# RENESAS TECHNICAL UPDATE

Product Category	MPU/MCU		Document No.	TN-RX*-A0279A/E	Rev.	1.00
Title	Errata Regarding Setting of the RCR4.RCKSEL Bit for the RX66N Group, RX72M Group, and RX72N Group MCUs		Information Category	Technical Notification		
Applicable Product	RX66N Group, RX72M Group, RX72N Group	Lot No.	Reference Document	User's Manual: Hardware for applicable products listed under Related Documents on the last page		
		All

Figure 9.11 Example of Initialization Flowchart When the Sub-Clock Is to Be Used as the Clock Source for the RTC

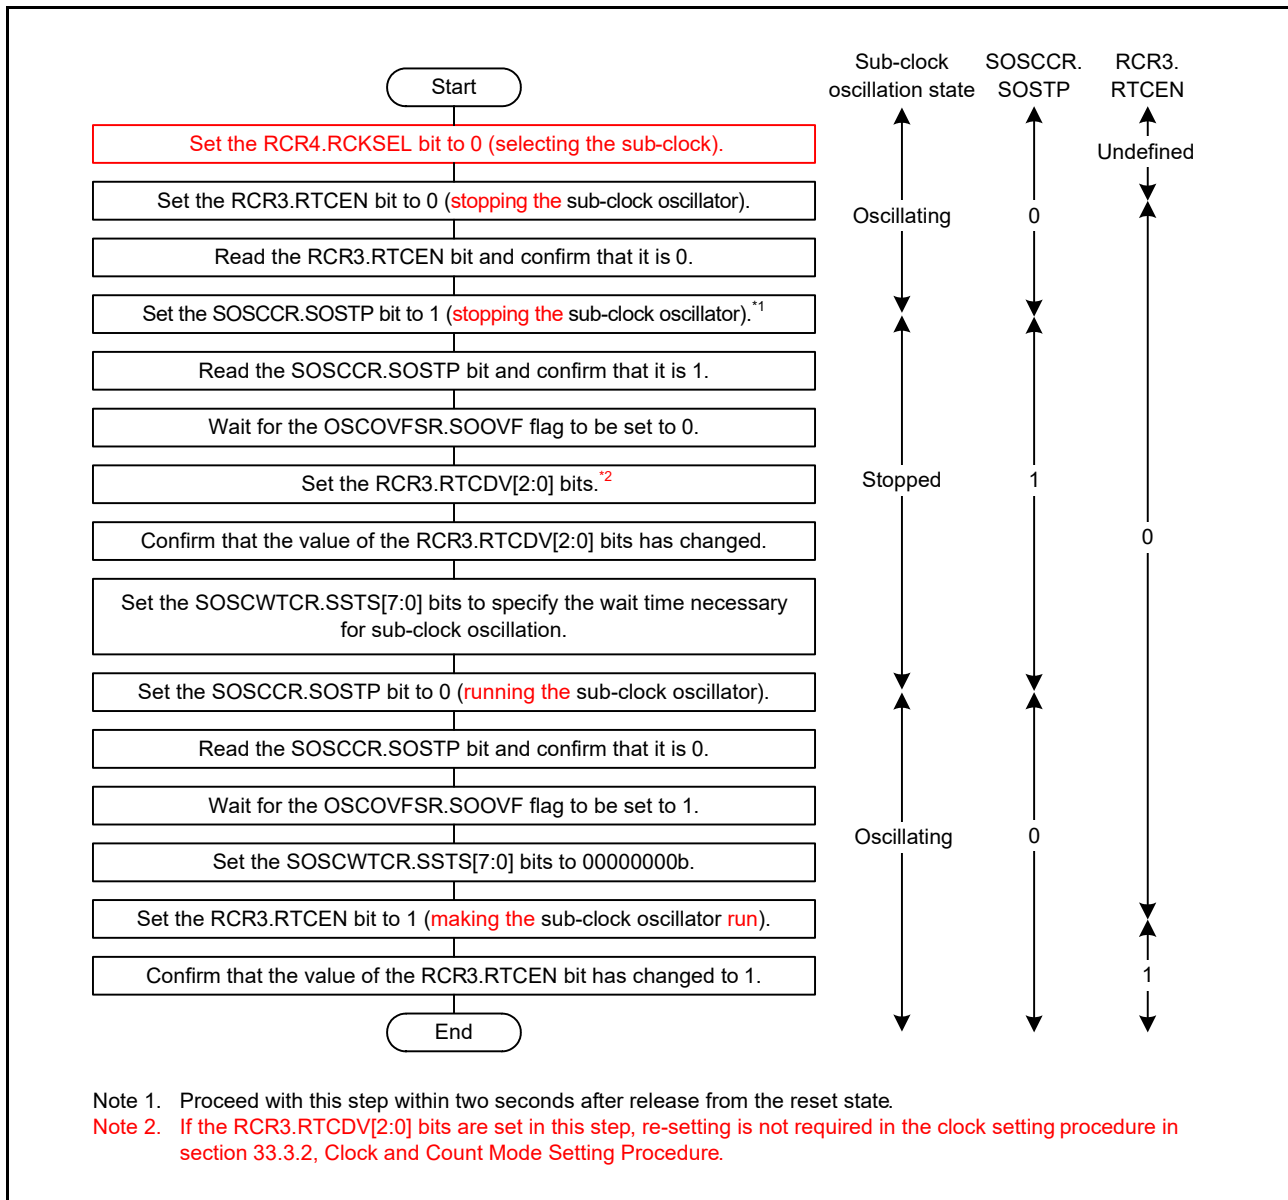
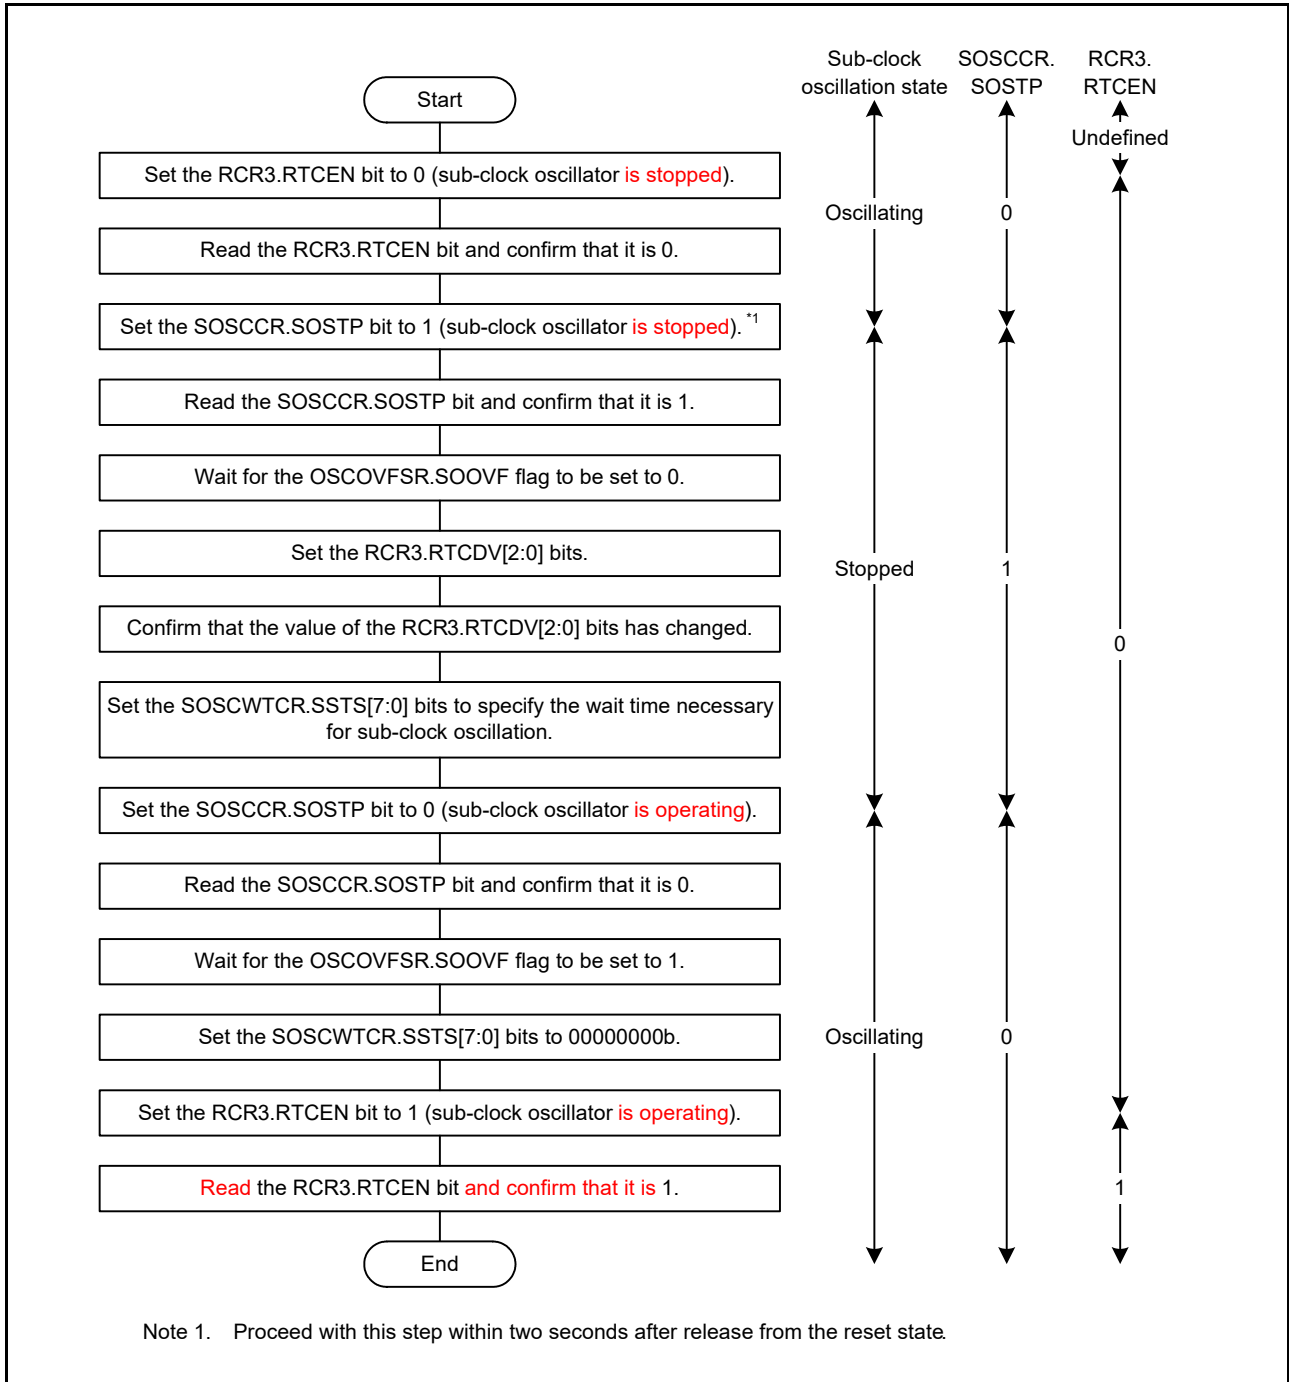
The following deletions are made in Figure 9.11, Example of Initialization Flowchart When Sub-Clock is Used as the Source to Drive Counting by the Realtime Clock.

- The RCR4.RCKSEL bit setting
- Note 2

The title of Figure 9.11 is also modified.

Figure 9.12 Example of Initialization Flowchart When the Sub-Clock is Not to Be Used as the Clock Source for the RTC

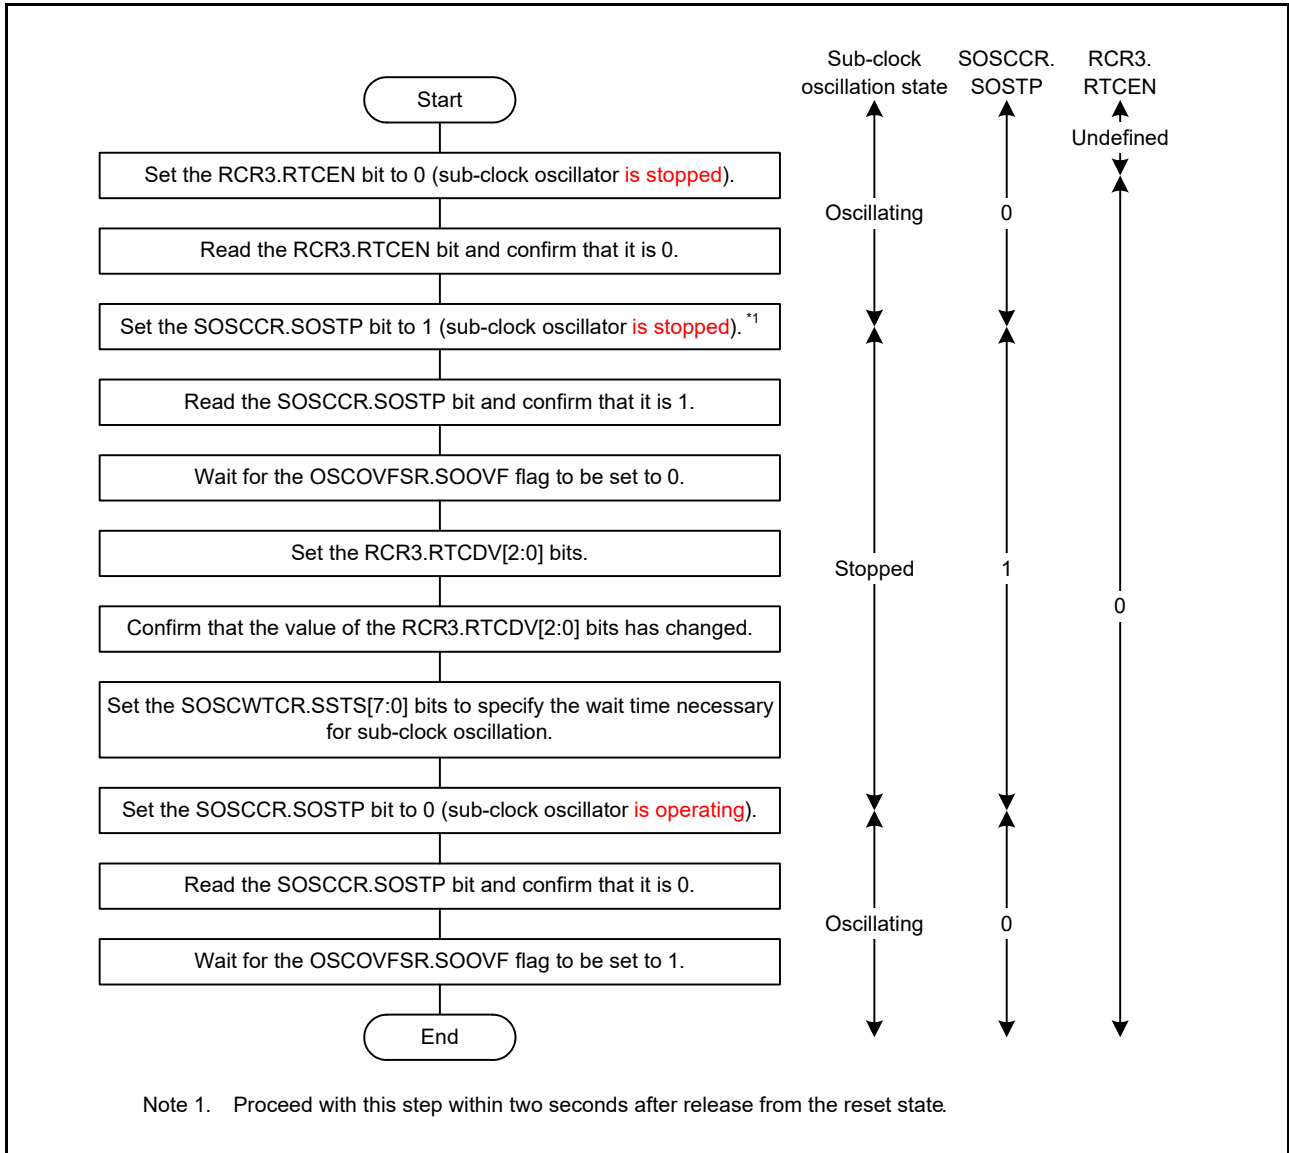
The following deletions are made in Figure 9.12, Example of Initialization Flowchart When Sub-Clock is Used Only as the System Clock.

- The RCR4.RCKSEL bit setting
- Note 2

The title of Figure 9.12 is also modified.

Figure 9.13 Example of Initialization Flowchart When the Sub-Clock Is Not to Be Used

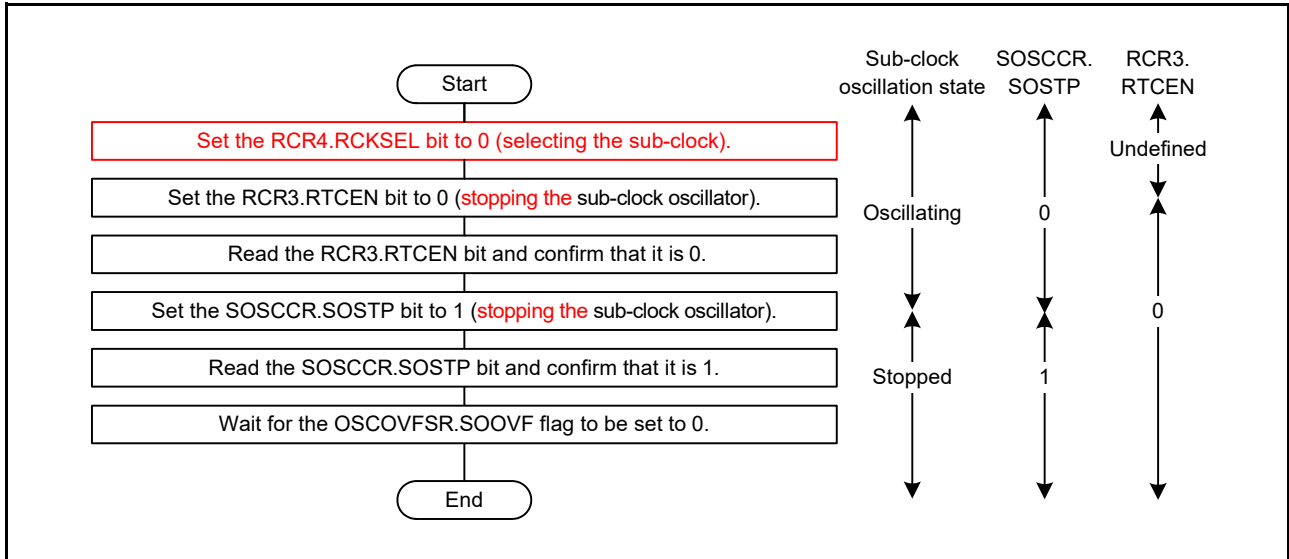
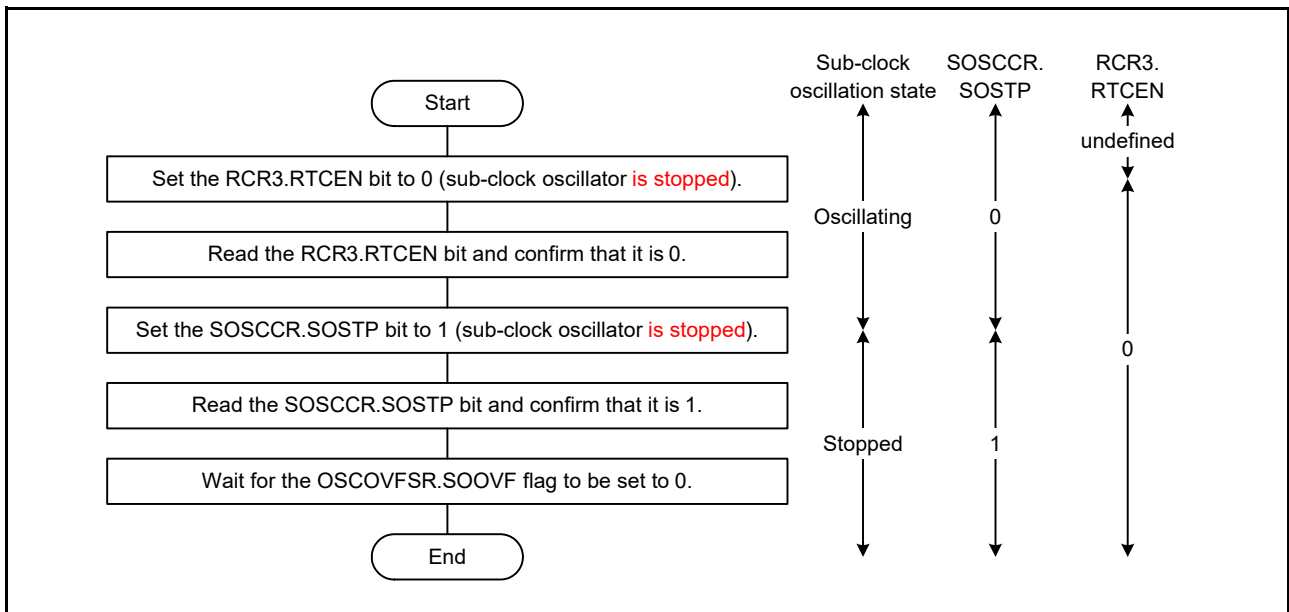
The following deletion is made in Figure 9.13, Example of Initialization Flowchart When Sub-Clock is Not Used.

- The RCR4.RCKSEL bit setting

Figure 33.3 Clock and Count Mode Setting Procedure (When Using Main Clock)

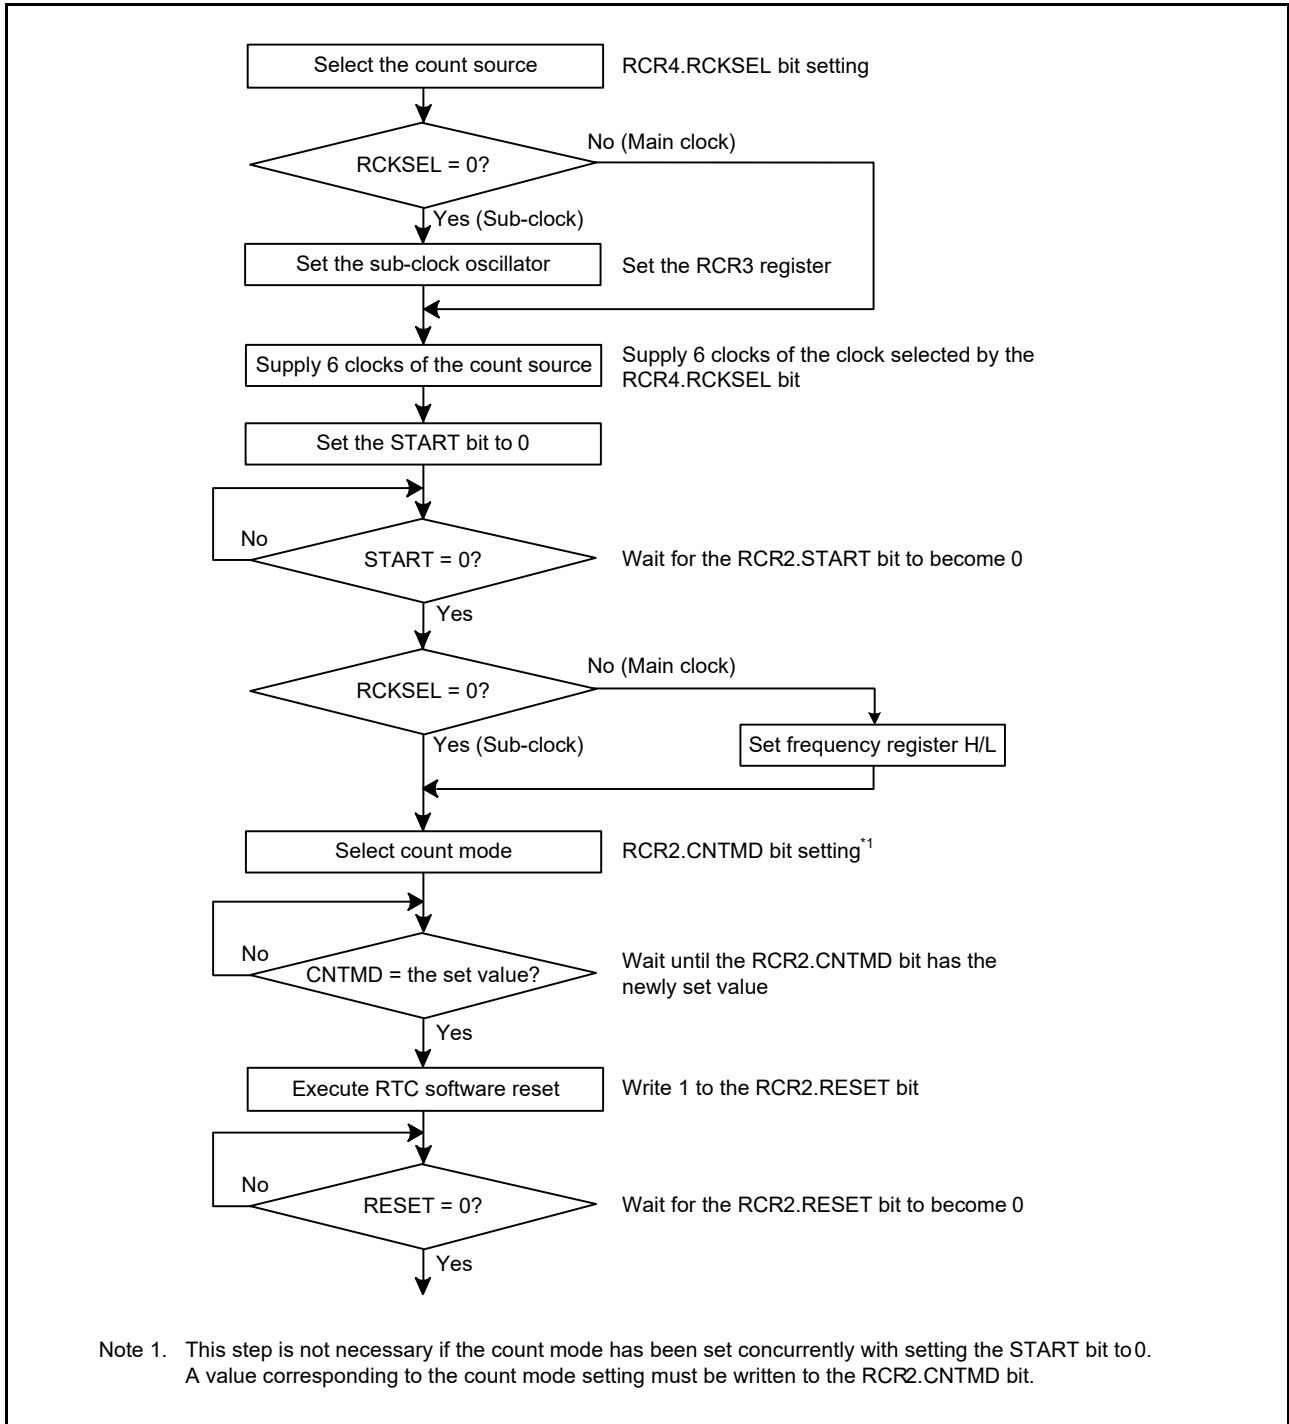
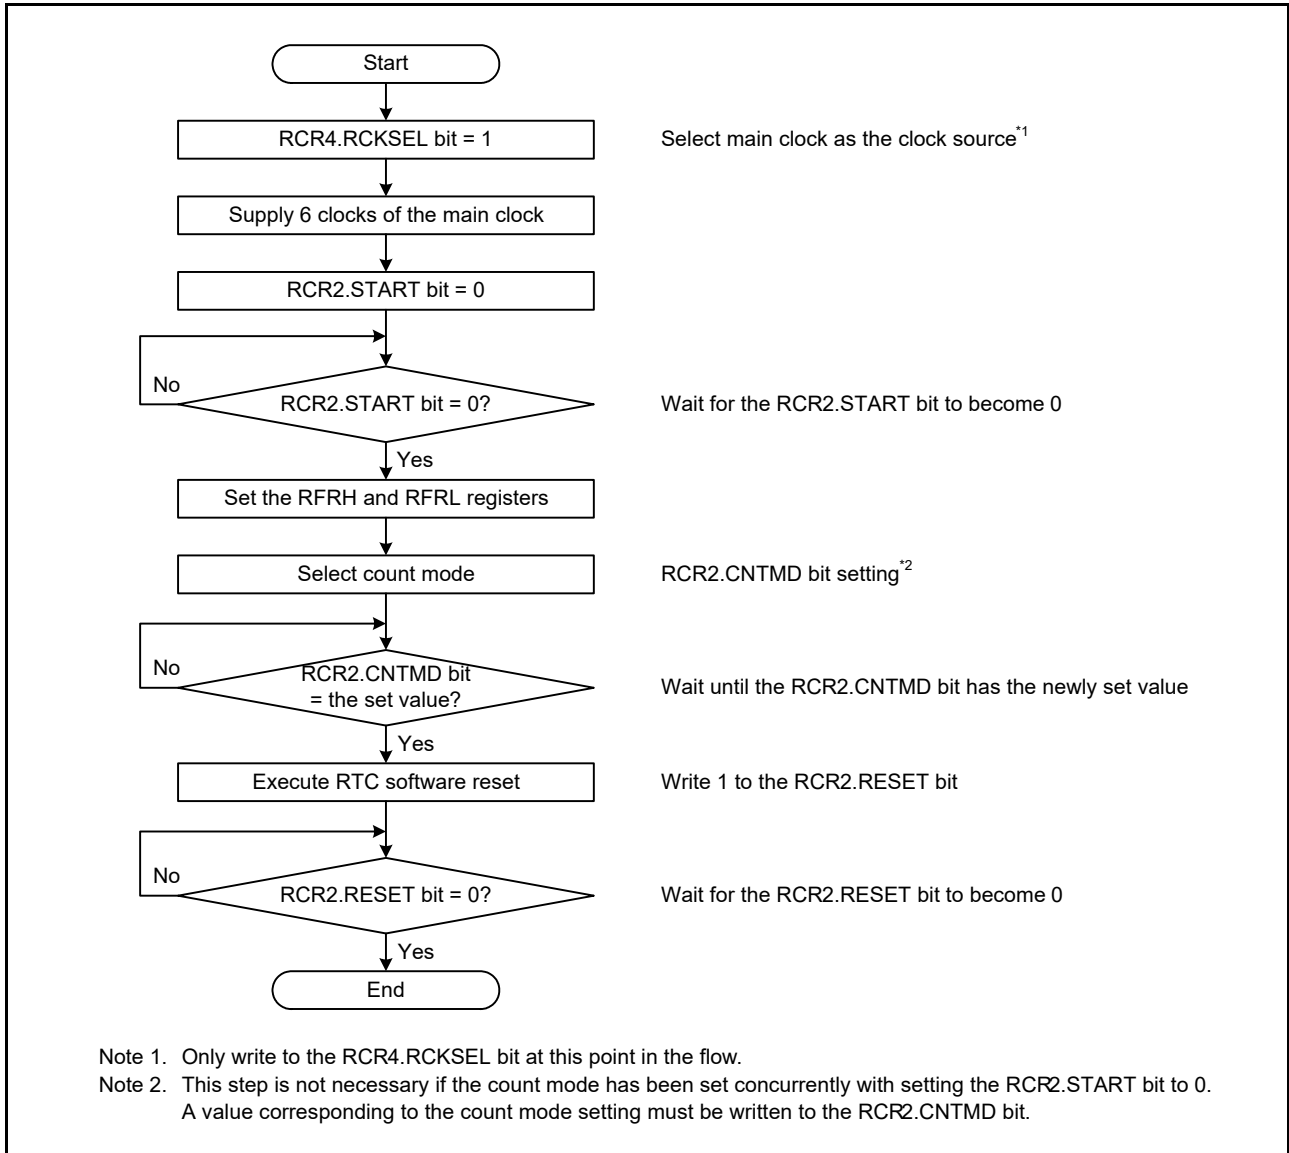
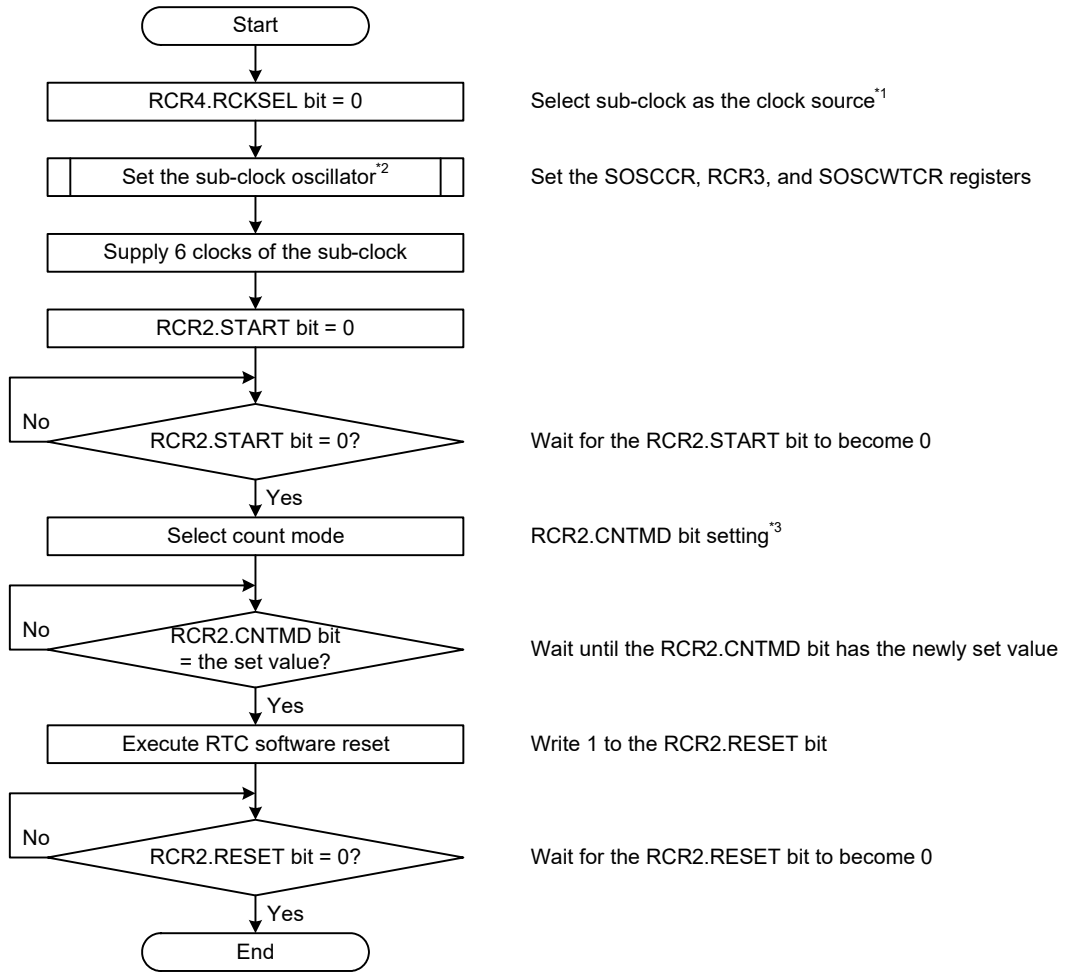
Figure 33.3, Clock and Count Mode Setting Procedure, in section 33.3.2, Clock and Count Mode Setting Procedure, is separated into two flowcharts as follows to suit the clock that is in use.

- Note 1. Only write to the RCR4.RCKSEL bit at this point in the flow.
- Note 2. For the procedure for setting up a sub-clock oscillator, refer to section 9, Clock Generation Circuit.
- Note 3. This step is not necessary if the count mode has been set concurrently with setting the RCR2.START bit to 0. A value corresponding to the count mode setting must be written to the RCR2.CNTMD bit.
